Solicitation Addendum

Addendum No.: 10
Solicitation No.: 19-TA003162CD
Project No.: 6086960 and 6045662
Solicitation Title: 44th Avenue East Extension Project- from 45th Street East to I-75
Addendum Date: January 29, 2020
Procurement Contact: Chris Daley, CPPO, CPPB- Procurement Manager

EXHIBIT
G

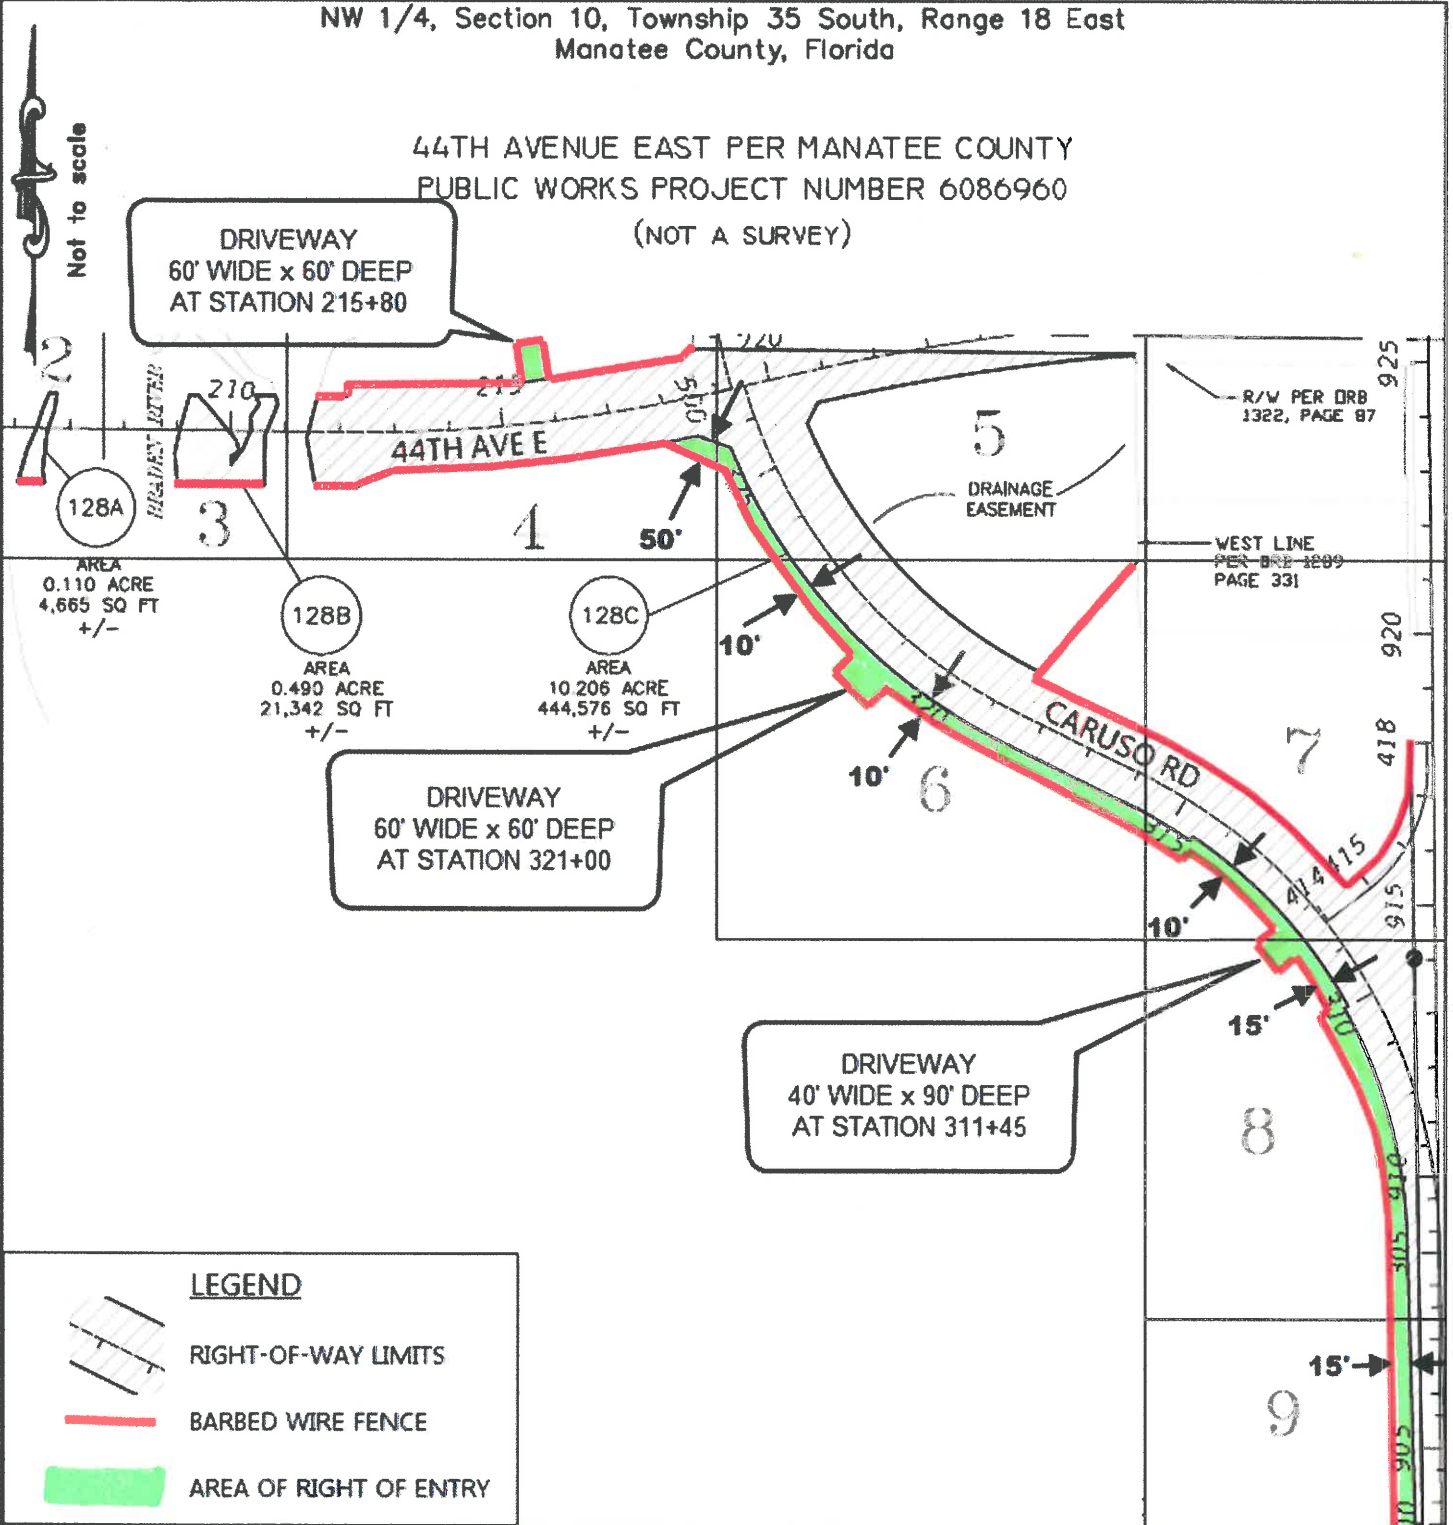
Bid Attachment 13- Adds location of new barbed wire fencing along with the material and installation requirements.

Bid Attachment 13, Barbed Wire Fence Installation issued with this Addendum No. 10, is hereby incorporated into this IFBC.
